Model: CH-C2 Pro		Date: 29-Mar-17	No.: RD260017
Subject: Electrical leak from fusing unit		Prepared by: S. Watanabe	
From: PP CS Section, PP FQM Dept., QAC			
Classification:	<input checked="" type="checkbox"/> Troubleshooting	<input type="checkbox"/> Part information	<input type="checkbox"/> Action required
	<input type="checkbox"/> Mechanical	<input checked="" type="checkbox"/> Electrical	<input type="checkbox"/> Service manual revision
	<input type="checkbox"/> Paper path	<input type="checkbox"/> Transmit/receive	<input type="checkbox"/> Retrofit information
	<input type="checkbox"/> Product Safety	<input type="checkbox"/> Other ()	<input checked="" type="checkbox"/> Tier 2

Model: Ch-C2 Pro		Date: 8-May-17	No.: RD260018
Subject: FSM correction –Minimum space requirements for the machine–		Prepared by: A.Shigeta	
From: 1st Tech Service Sec. MFP Tech Service Dept.			
Classification:	<input type="checkbox"/> Troubleshooting <input type="checkbox"/> Mechanical <input type="checkbox"/> Paper path <input type="checkbox"/> Product Safety	<input type="checkbox"/> Part information <input type="checkbox"/> Electrical <input type="checkbox"/> Transmit/receive <input type="checkbox"/> Othe

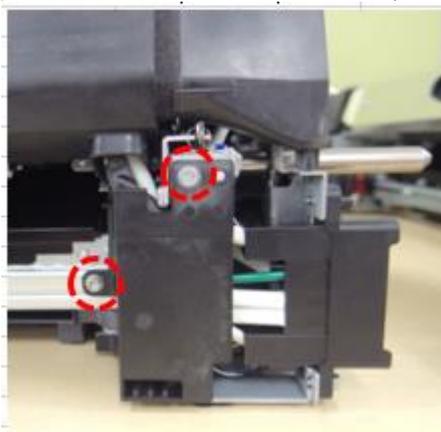
The harness layout was changed when the factory assembly team was changed in January 2017. As a result, the following harness tube in the fusing unit was damaged, causing it to contact the metal plate.

1. Check the target harness tube.
2. If it is damaged, cover the harness with Teflon tape.
3. Cover the edge of the bracket with Teflon tape.

Note: The recommended Teflon tape is 3M PTFE Film tape 5490 (24mm).

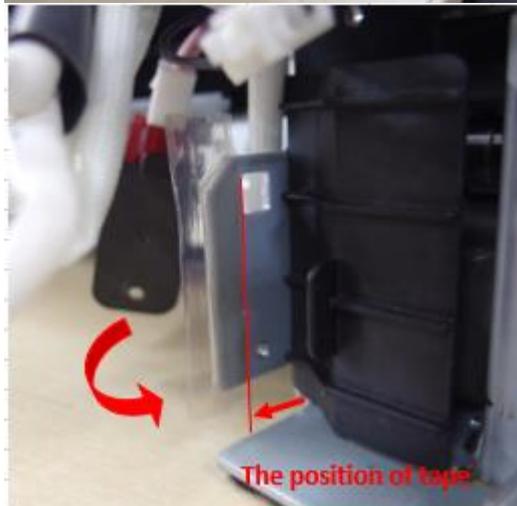
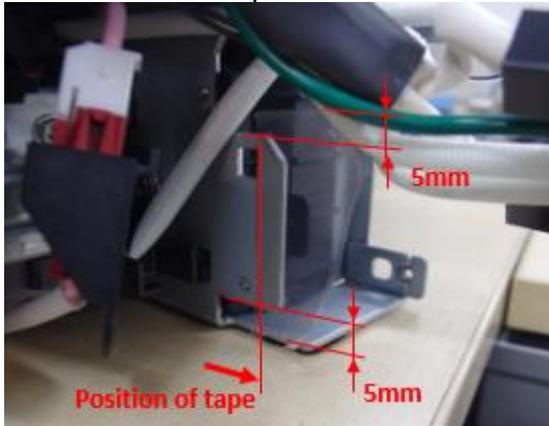
7. Attach the Teflon tape at the following locations on the bracket.

Important: Make sure the tape sticks out 5mm from the top and bottom, as shown in the photos below.

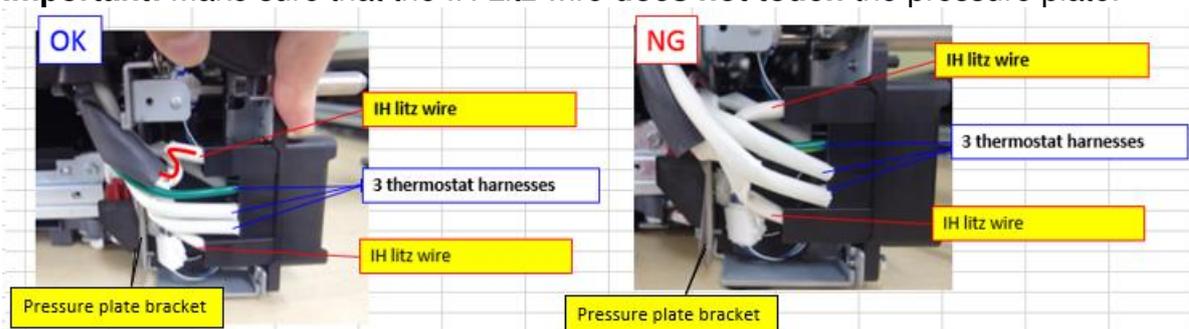
11. Attach the drawer connector (2 screws).

Important: Make sure that the IH Litz wire **does not touch** the pressure plate.

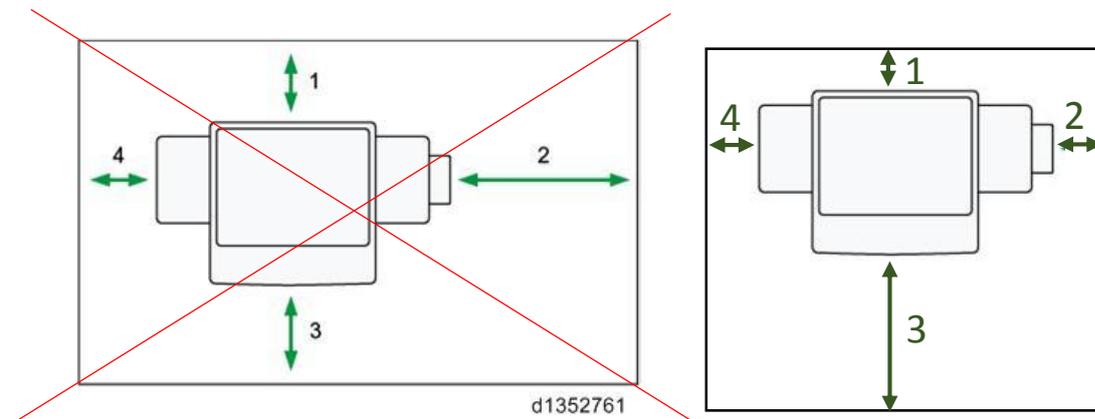
The minimum space requirements for the machine was corrected in the following section of the Service Manual:

2. Installation > Installation Requirements > Minimum Space Requirements

1 Rear	100mm (4")
2 Right	900mm (35.5") 150 mm (5.9")
3 Front	400mm (15.7") 800 mm (31.5")
4 Left	100mm (4") 150 mm (5.9")

Important notice regarding installation procedure of the Smart Operation Panel Type S6 (D3C9)

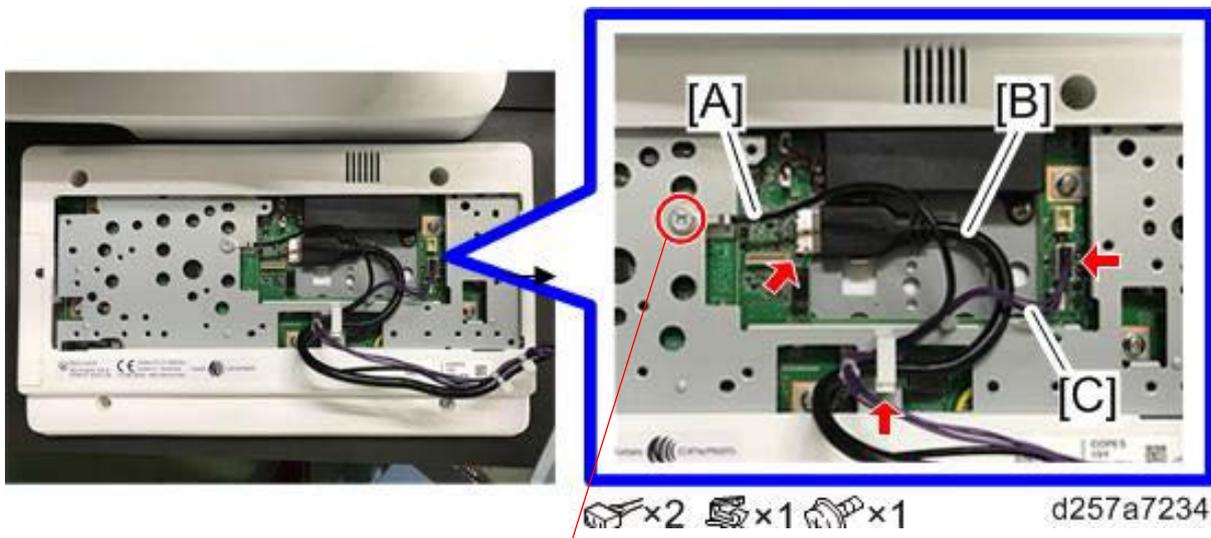
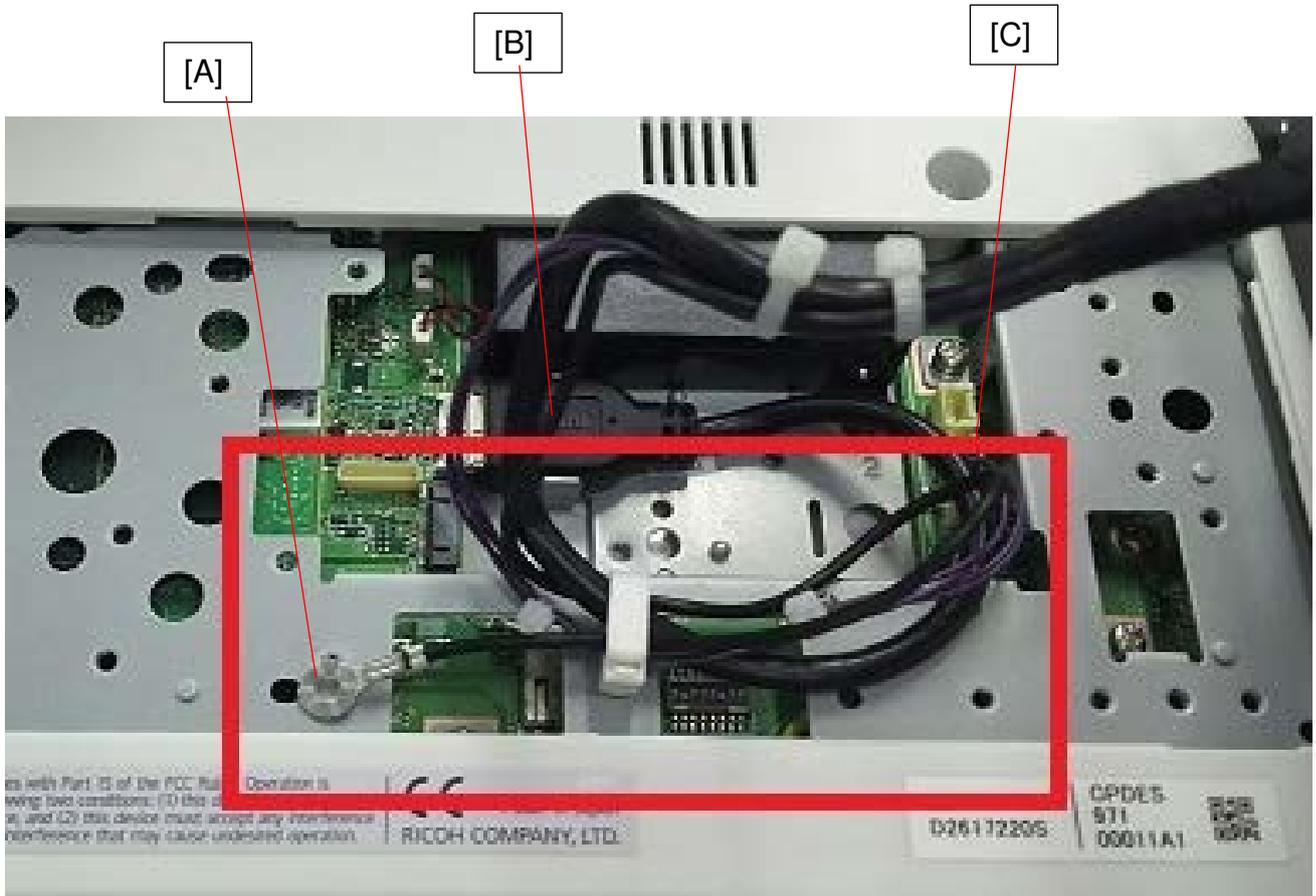
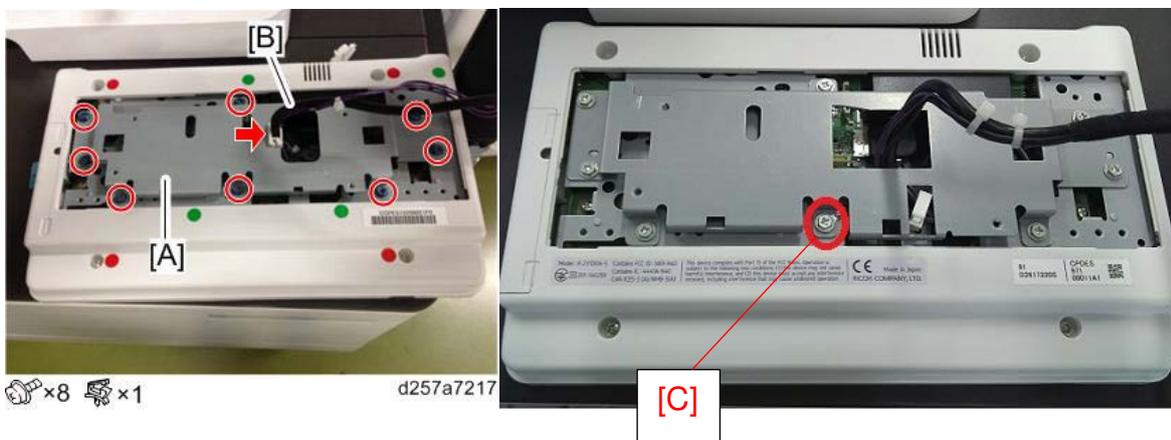
When installing the Smart Operation Panel, fixing the ground cable before attaching the arm bracket has the risk of damaging the IC chip in the panel and cause a blank screen, because the screw used for fixing the ground cable may have contact with the IC chip.

To prevent the above, please correct the installation procedure as follows.

11. Connect the harnesses [B] and [C] to the operation panel, and then route them as shown below.
12. Fix the ground cable [A].

13. Attach the arm bracket [A] to the operation panel, and then fasten the harness [B] with the clamp.

- 11. Connect the harnesses [B] and [C] to the operation panel, and then route them as shown below.
- 12. Fix the ground cable [A].

- 13. Attach the arm bracket [A] to the operation panel, fix the grounding cable [C] together with the bracket, and fasten the harness [B] with the clamp.

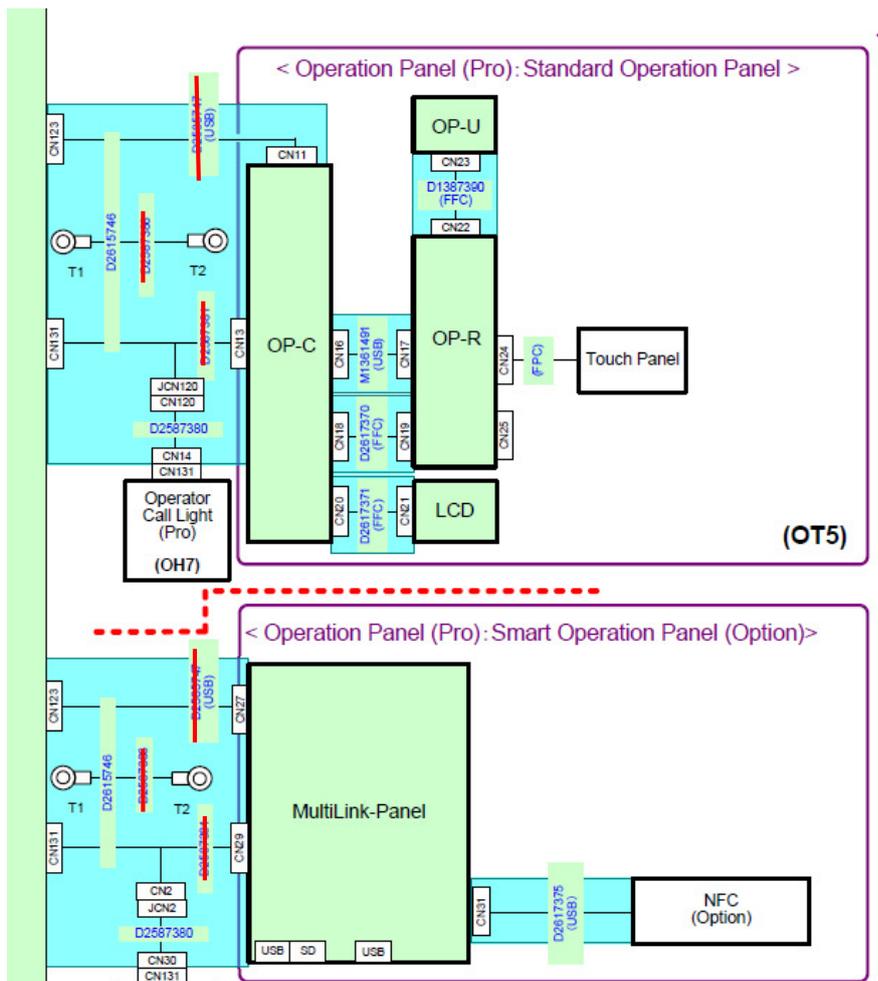
Change: Please remove the above harness part numbers from the P-to-P diagram.

Reason: These harnesses are not supposed to be listed in the P-to-P diagram as individual parts, because they are included together with binders (x4) and an insulating tape in the assembly registered with the p/n: D2615746.

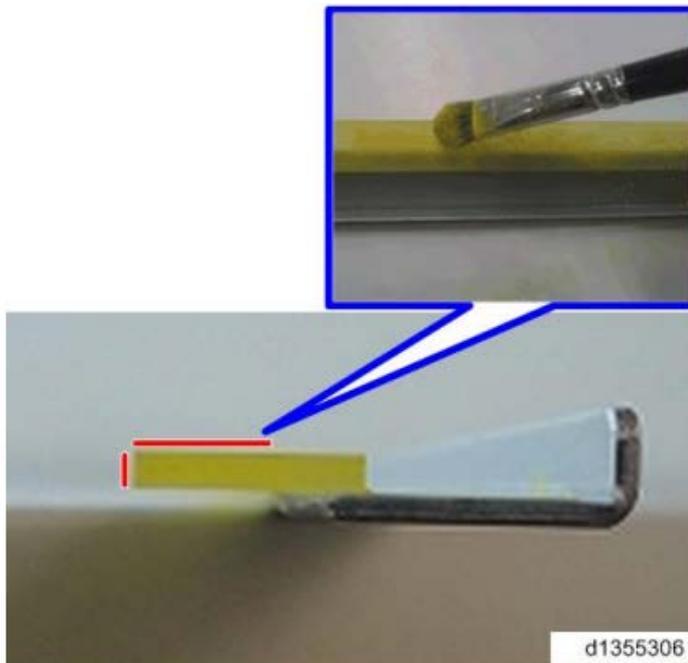
Please add the following descriptions in **bold** in section Cleaning blade (Add Note for Yellow toner lubrication).

Before installing the cleaning blade, use a brush to apply yellow toner (D0149500) evenly across the surfaces of the new blade indicated with the red lines in the illustration below.

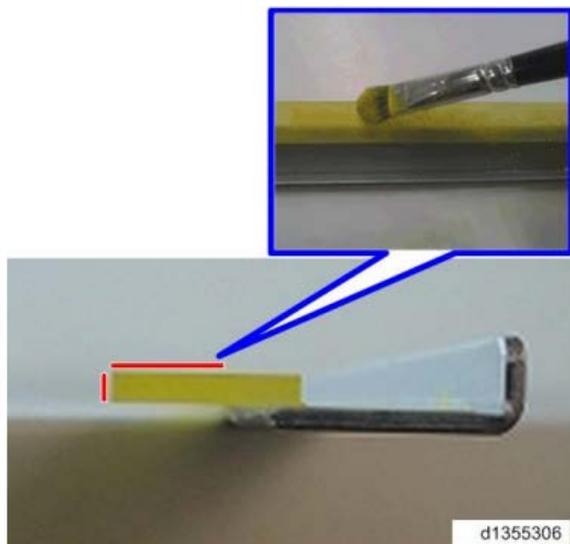
Note

Before installing the cleaning blade, use a brush to apply yellow toner (D0149500) evenly across the surfaces of the new blade indicated with the red lines in the illustration below.

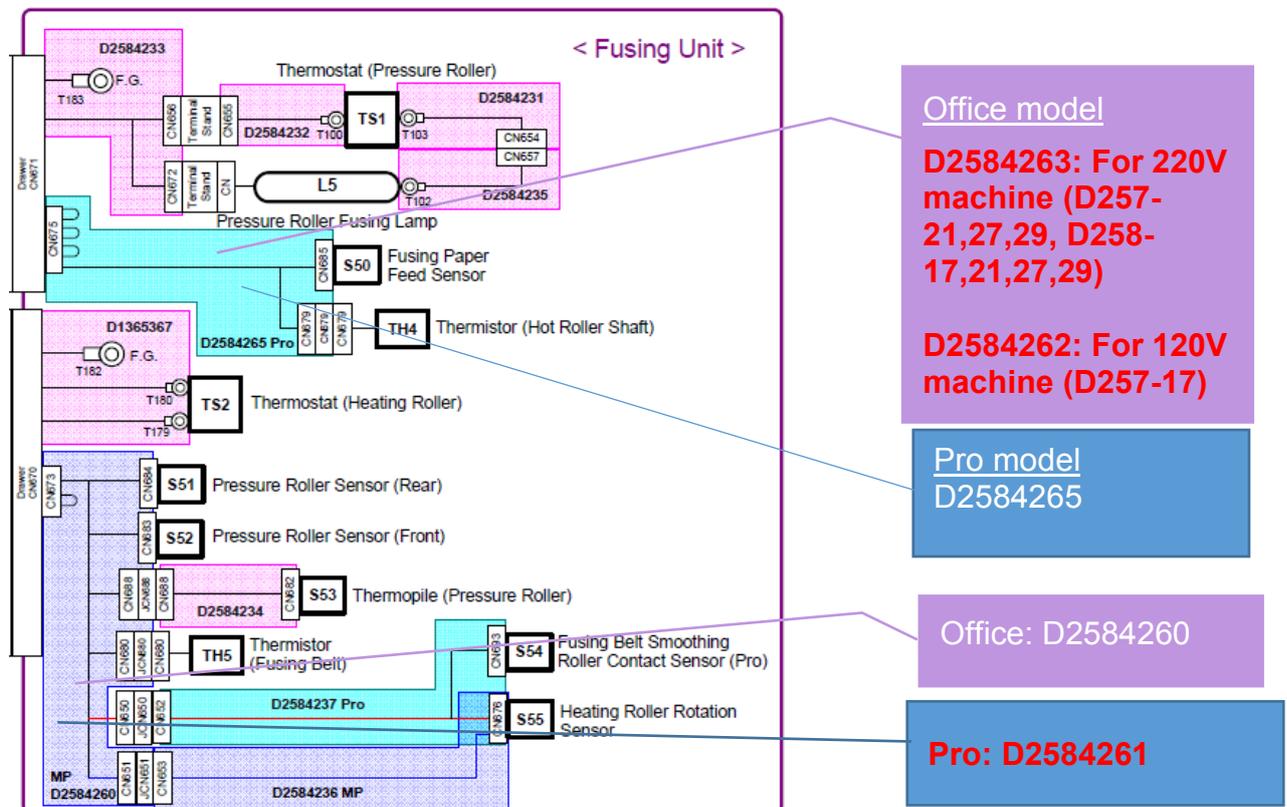
Change: The above three part numbers were added to the P-to-P diagram.

Reason: The part numbers were missing from the P-to-P diagram.

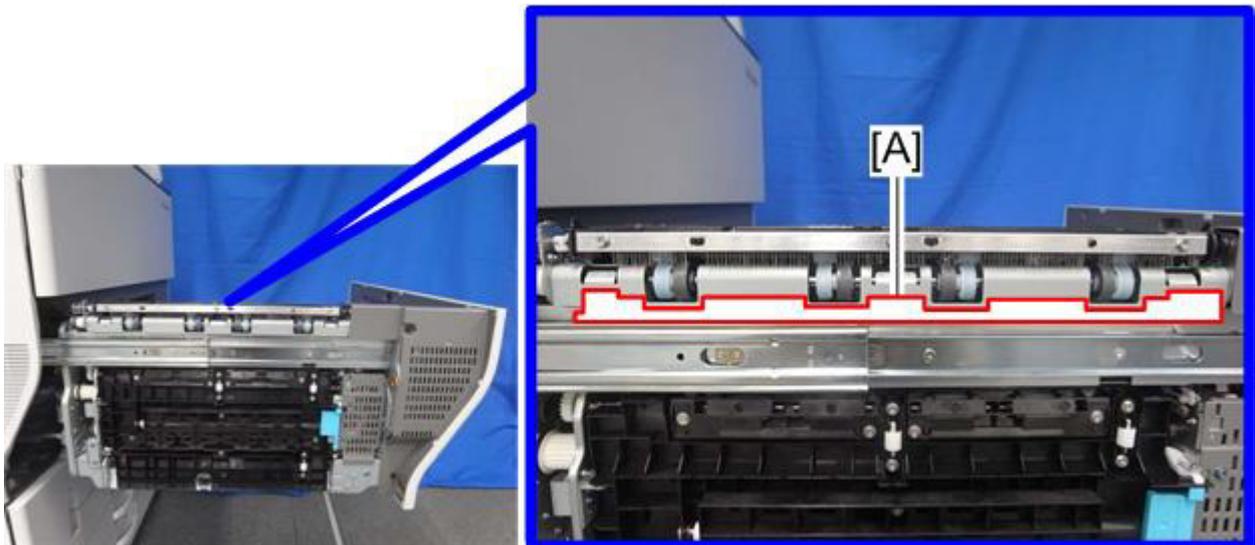
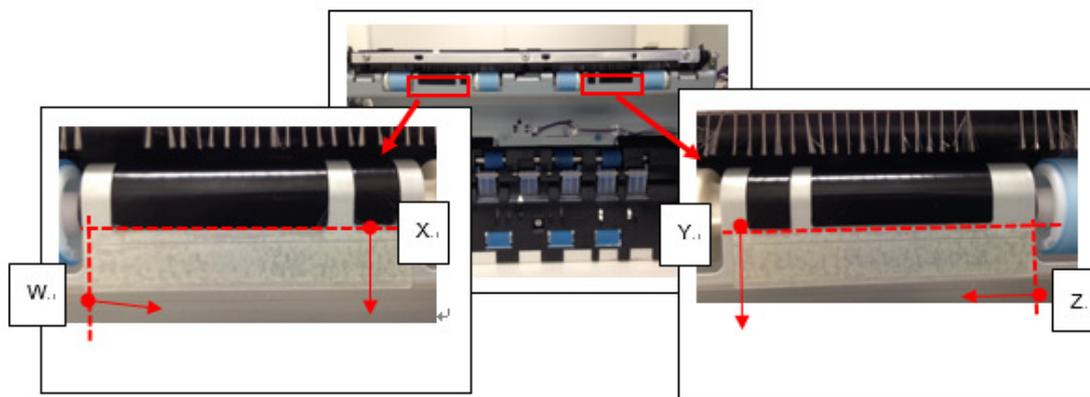
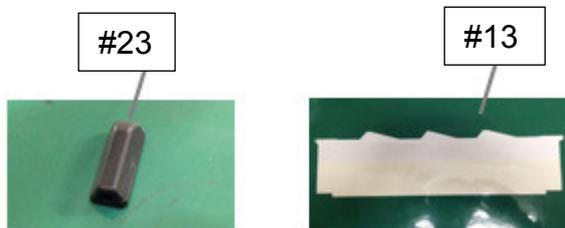
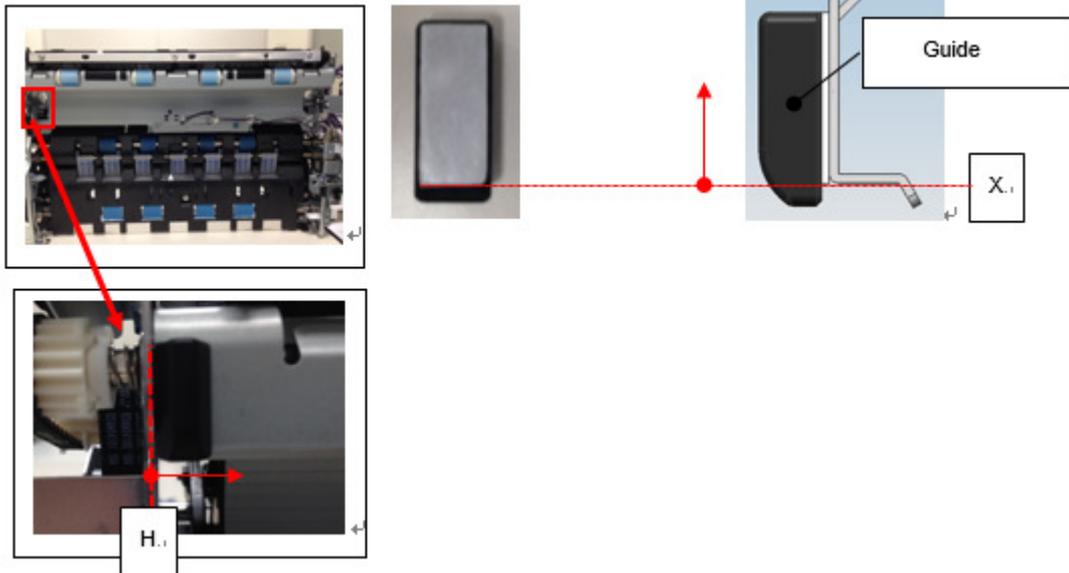
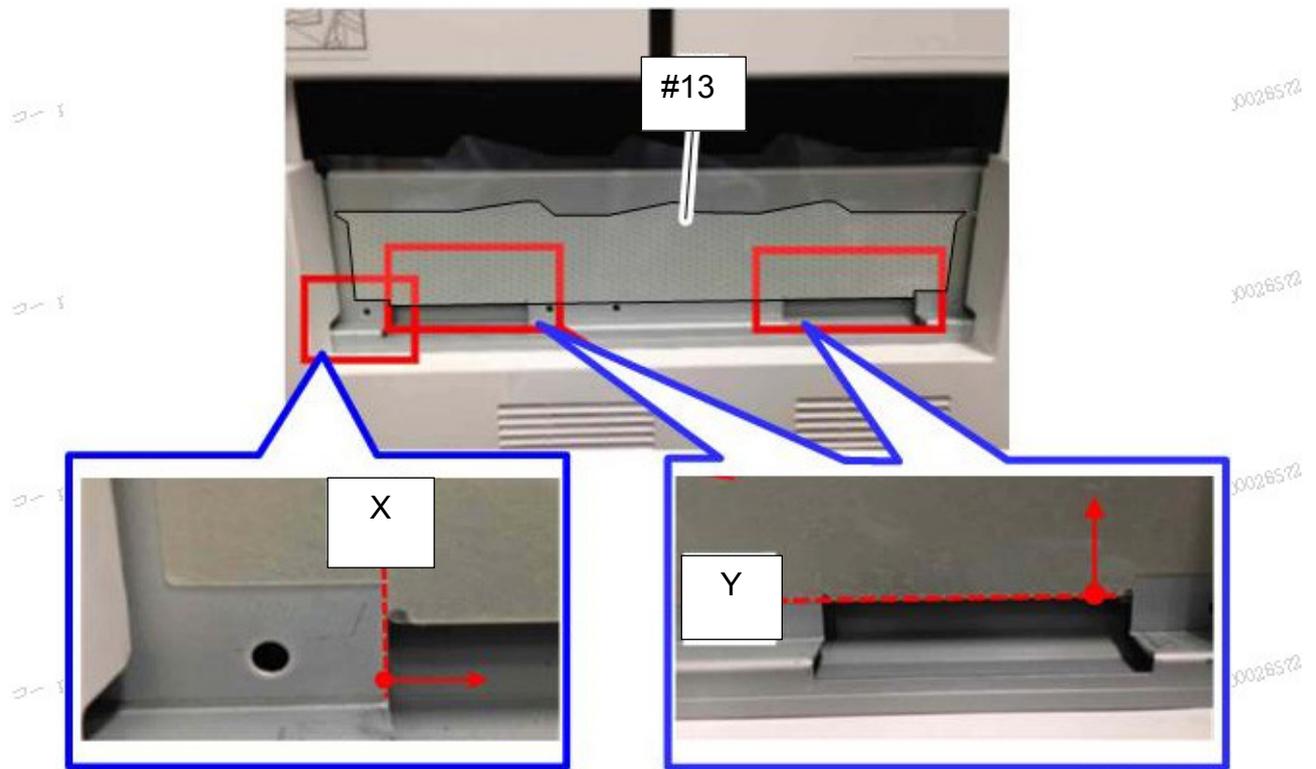
Please correct the Copy Tray Type M26 Installation procedure described in the section:
2. Installation > Copy Tray Type M26(D3D2)

12. Attach the sheet [A] to the left side of the drawer unit.

Step 12 was separated into the following four steps.

- Attach the two sheets indexed #24 to the paper exit unit by aligning the corners W/Z and edges X/Y.
- * Tolerance: 0~0.5mm

- a. With the drawer unit pulled out, attach the guide [#23] to the non-operator side of the paper exit unit by aligning the edge H with edge X.

- b. Attach the sheet [#13] to the exit of the mainframe by aligning the corner X with edge Y.

131.D2616005
TRANSFER UNIT:INTERMEDIATE TRANSFER:240V:ASS'Y

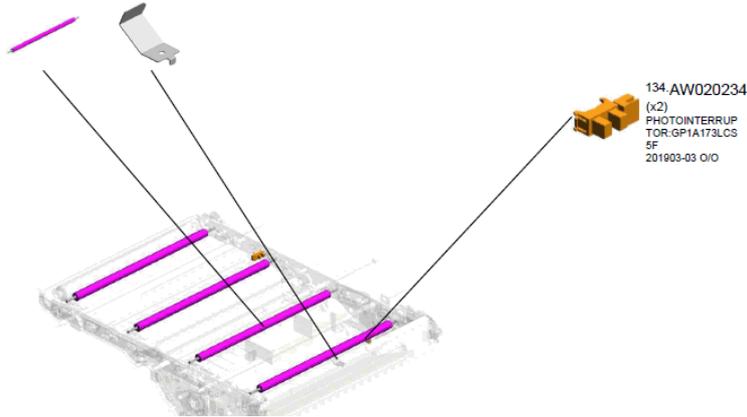
For any replacement of the image transfer roller that takes place after July 21, 2019 for Charis-C2 Pro (Pro C5200S/ C5210S), please make sure to replace it with the new roller (p/n: D2586166).

3D parts catalog was revised as follows.
